Customer Service Bulletin
Commercial Business Group

ProCore® 648 Aerator

Model/Serial Range:	Model Number:	Serial Numbers:
	09200	240000101-260009999

Subject: The Aerator Tears or Lifts Turf on Entry or Exit

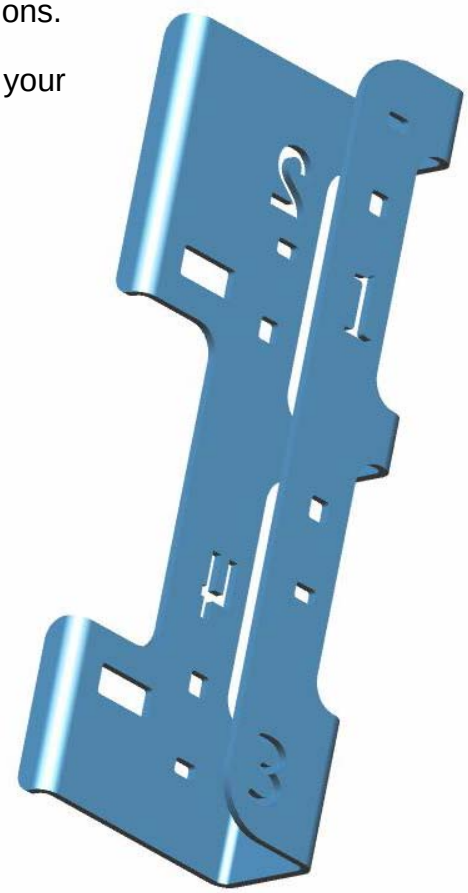
Some complaints have been reported in early and late season applications regarding the subject of this bulletin. They include descriptions of torn or “lifted” turf on entry to an aeration pass or during the exit from the aeration pass. The basis of this complaint was determined to be shallow root conditions aggravated by a slight mismatch in coring head run up or run down timing in relation to traction speed.

Clutch Switch Kit (112-6515) was developed as a product improvement to address this specific turf condition. Installation of this kit will address these complaints by allowing variation in the position of the coring head drive clutch control switch during the coring head drop and raise sequences. This adjustment allows the coring head clutch to engage sooner; the coring head speed will more closely match the traction speed as the tines enter and exit the soil in shallow root structure conditions.

Clutch Switch Kit (112-6515) is currently available through your local Toro Commercial Products Distributor.
